PRELIMINARY OVERALL AREA DEVELOPMENT PLAN

P.O.A.D.P.
EASTWOOD INDUSTRIAL PARK

Re: Eastwood Industrial Park POADP
File # 85-18-58-66

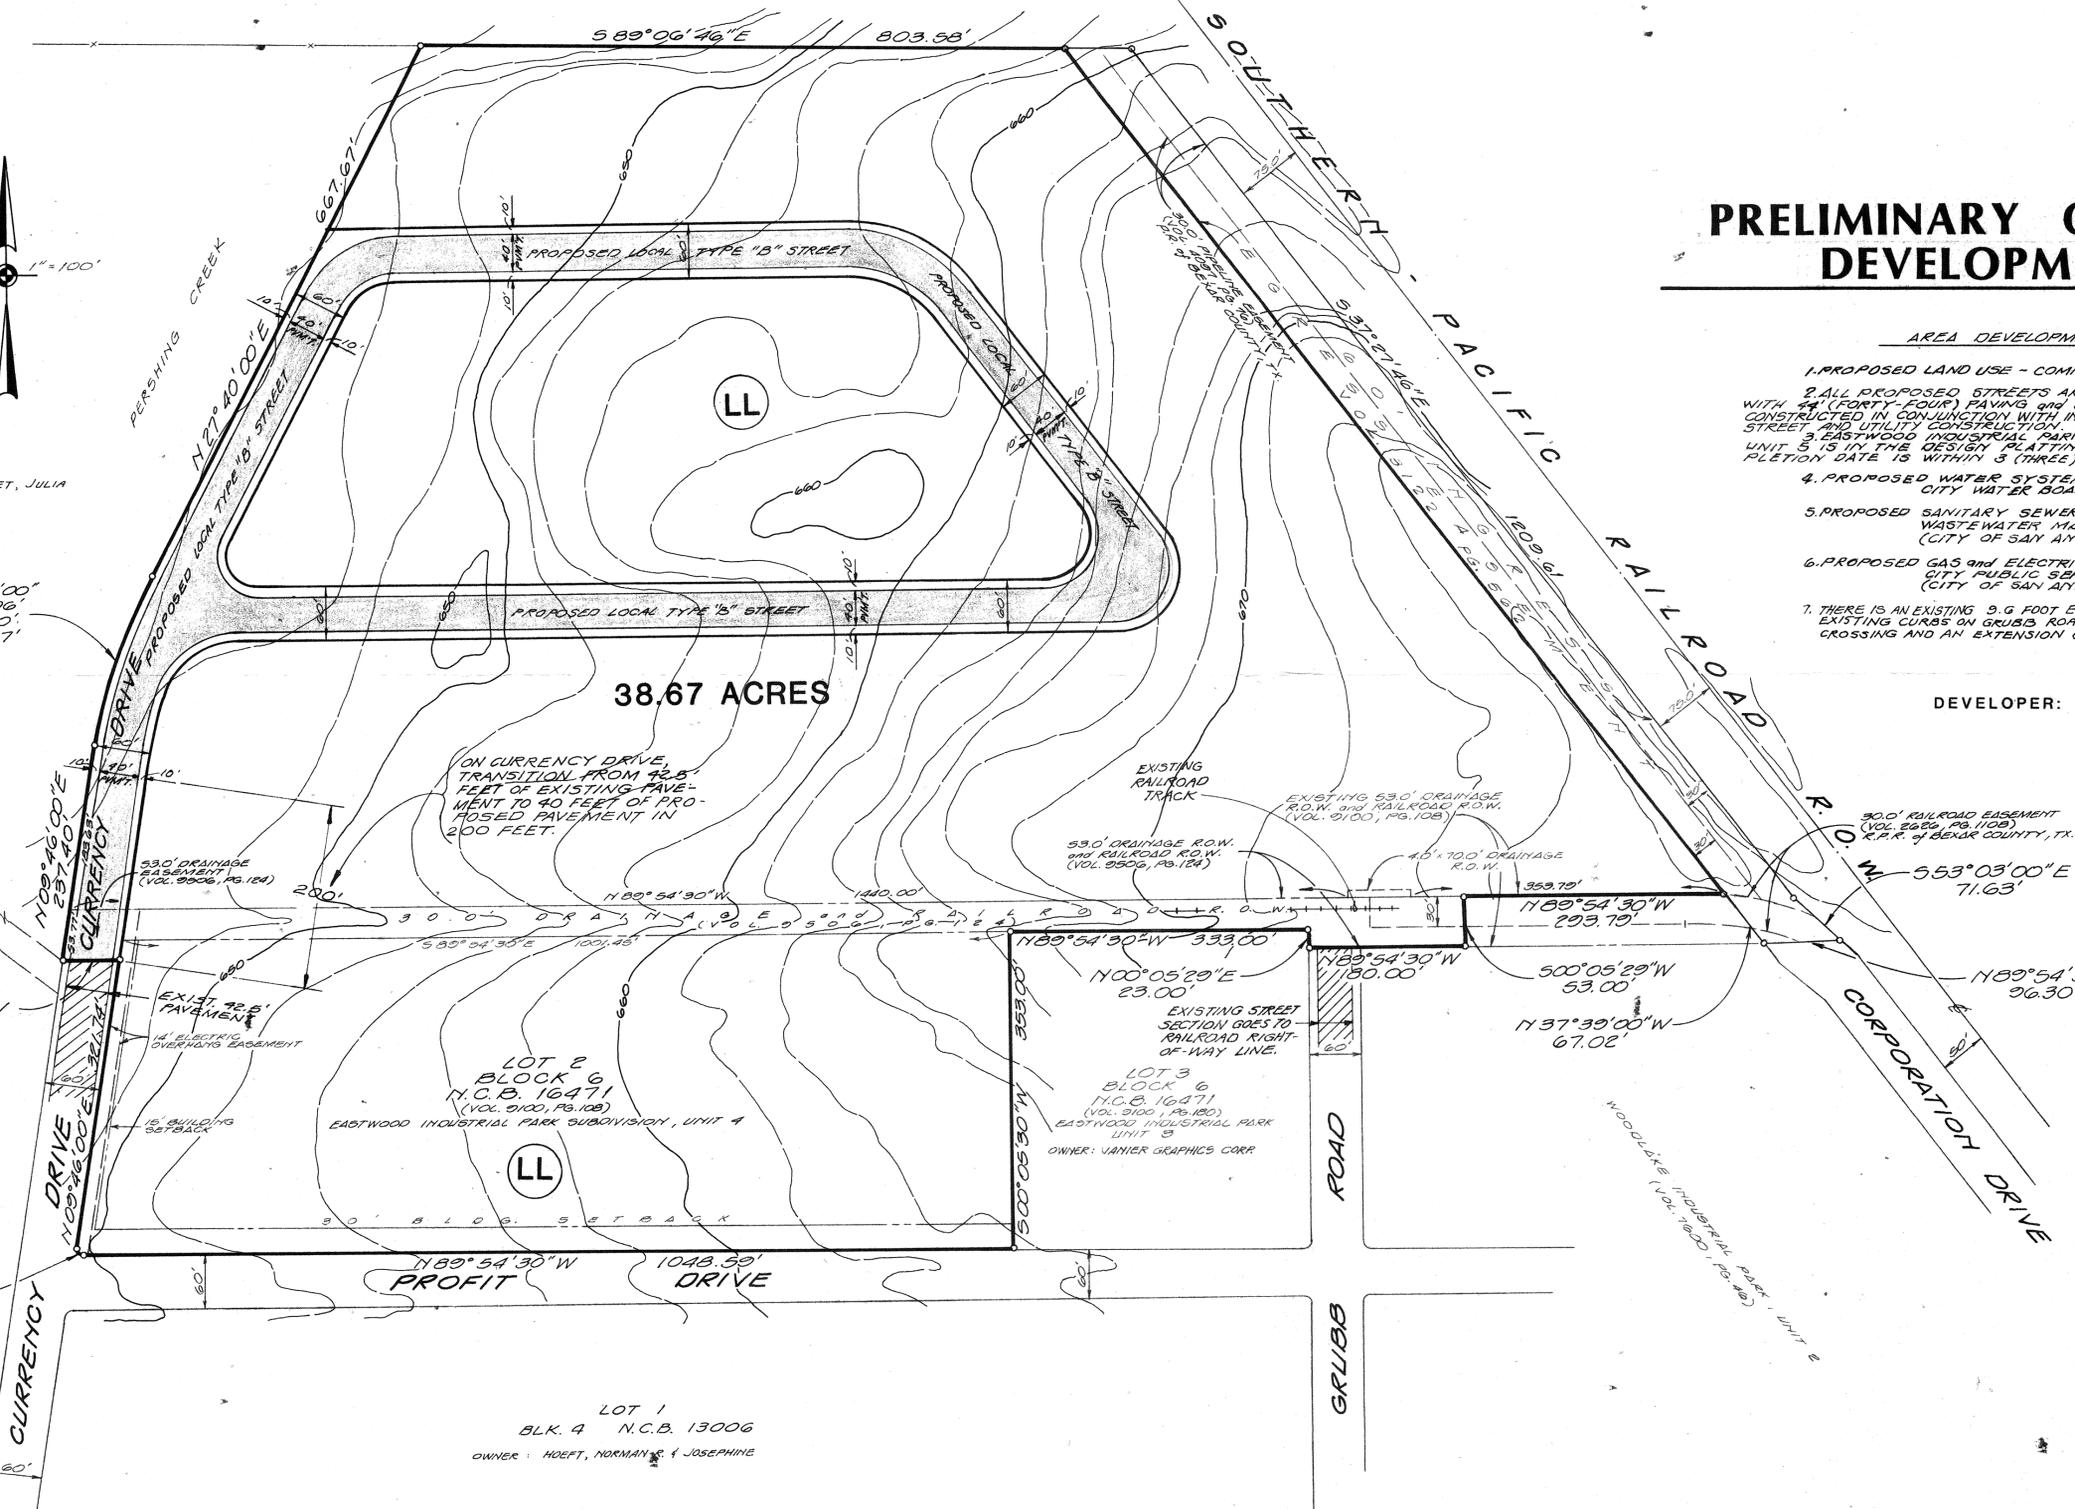
The POADP Committee has reviewed and accepted your proposed plan for Eastwood Industrial Park. It is noted however, that a violation to Sec. 36-10(B) (Relation to adjoining street system) will be cited upon formal plat filing where Grubb Road deadends upon the property.
